DC UNITED TRAINING SITE

CONSTRUCTION DOCUMENTS

AS-BUILT PLAN

AS-BUILT SURVEY INFORMATION NOTED IN RED AS BOXED

SEWER EXTENSION PROFILES

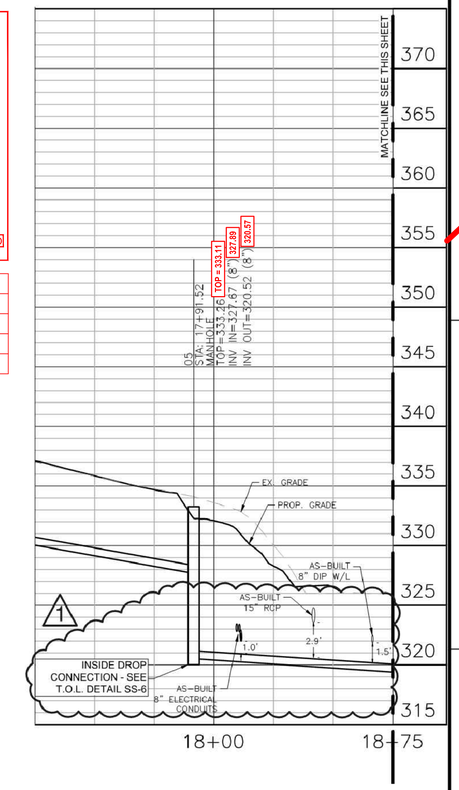
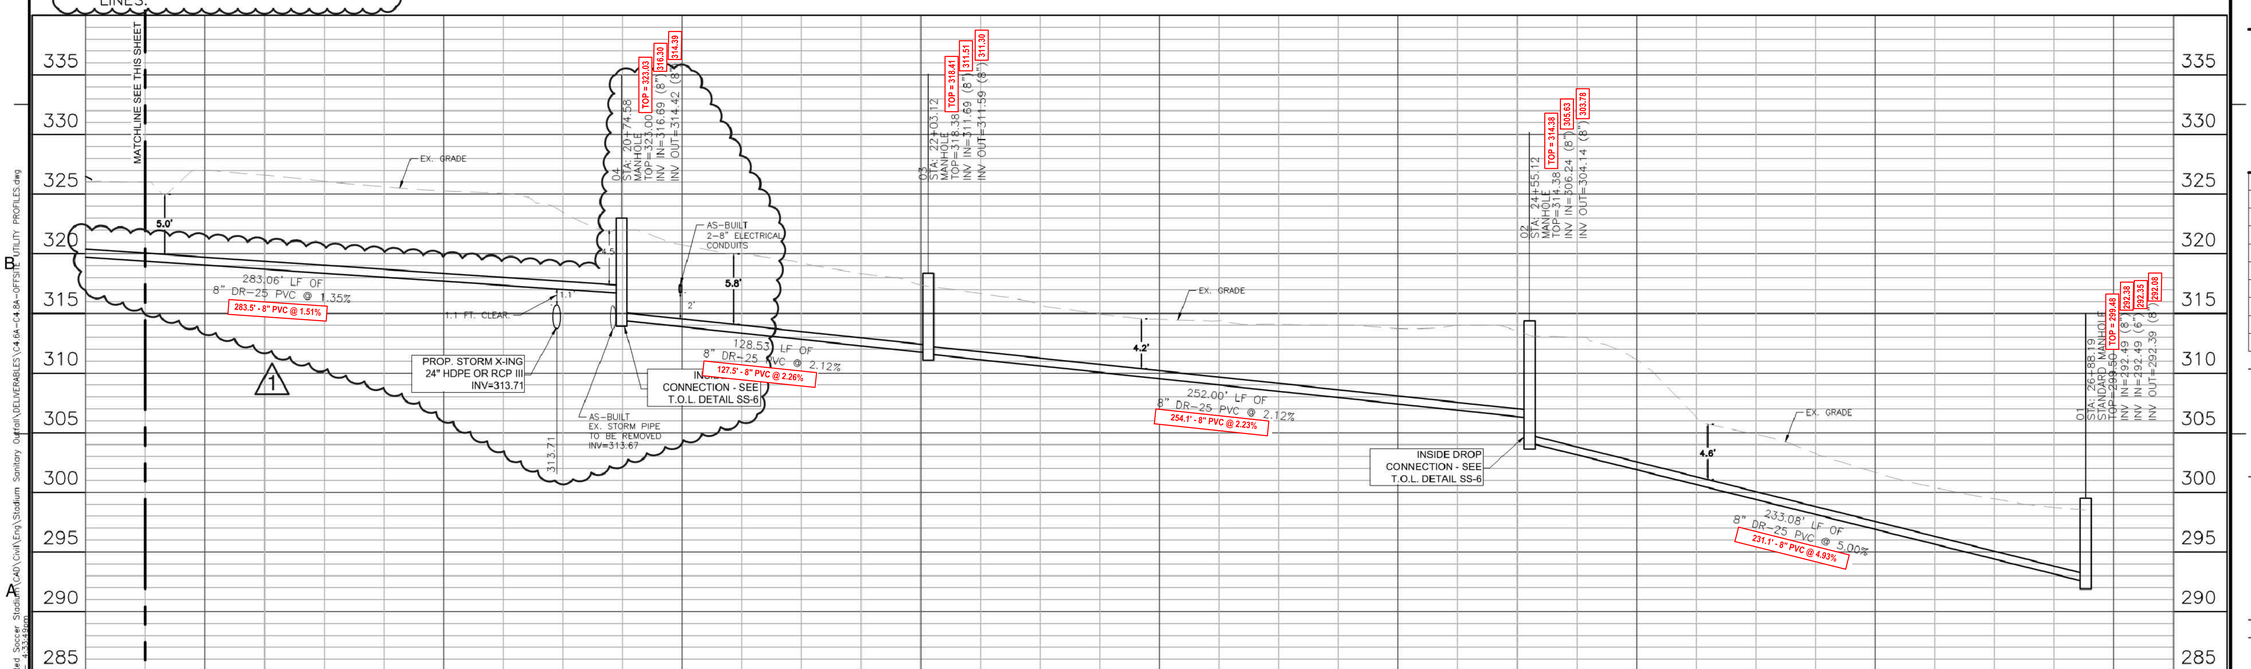
CLOUDED AREA BEING REVISED WITH THIS PLAN.

SEWER EXTENSION PROFILES

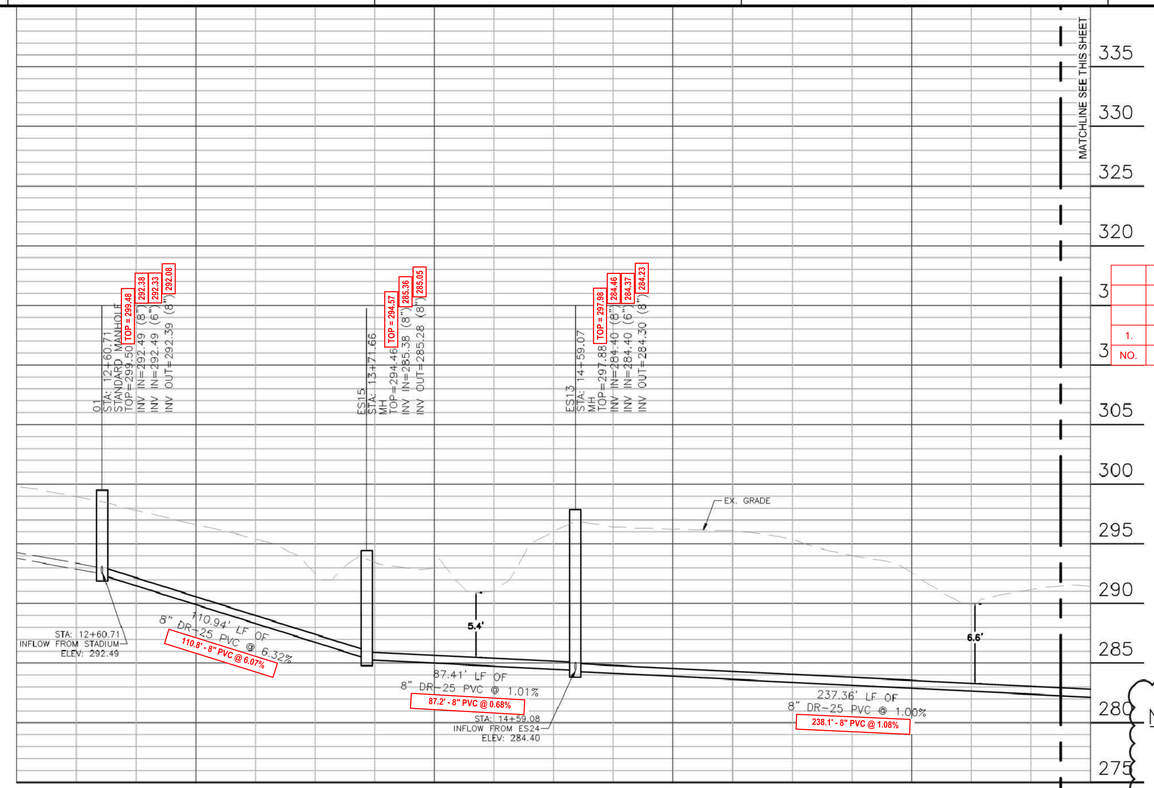
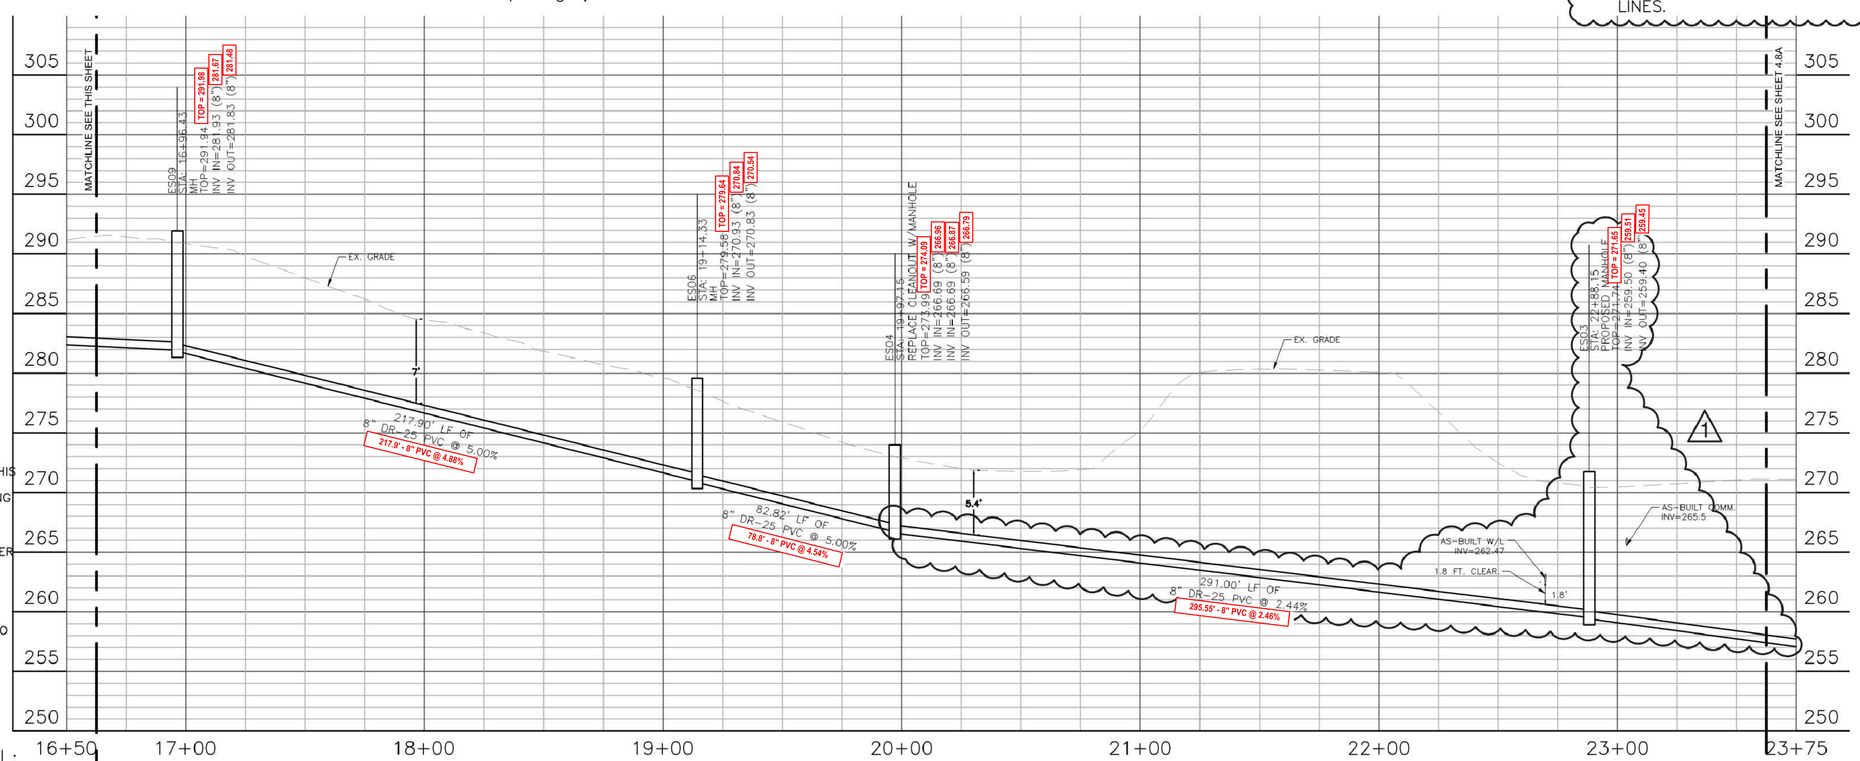
CLOUDED AREA BEING REVISED WITH THIS PLAN.

SEWER EXTENSION PROFILES

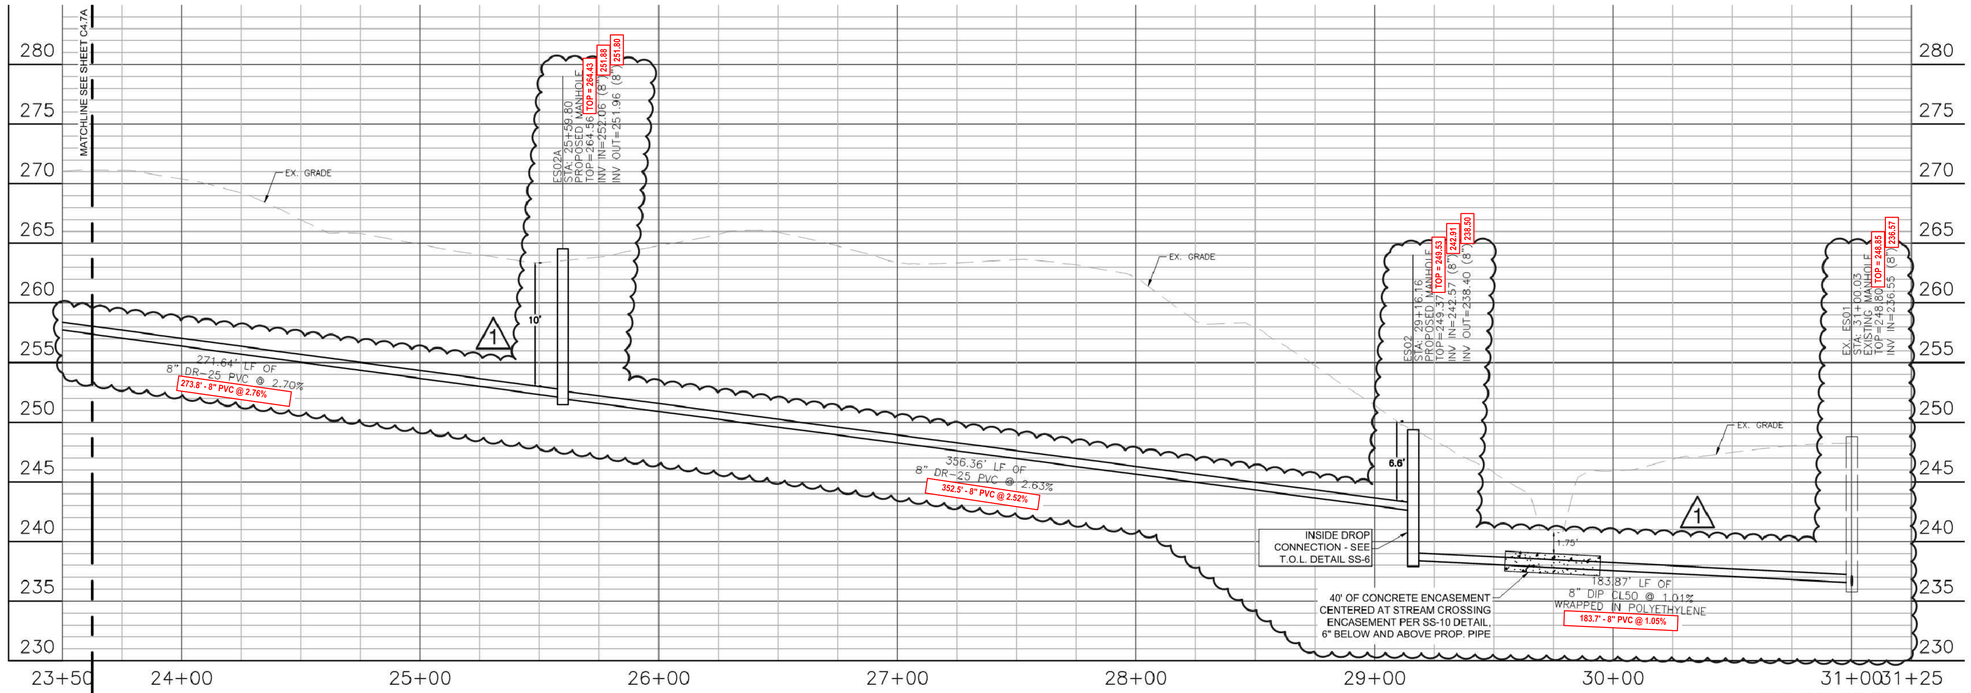
CLOUDED AREA BEING REVISED WITH THIS PLAN.
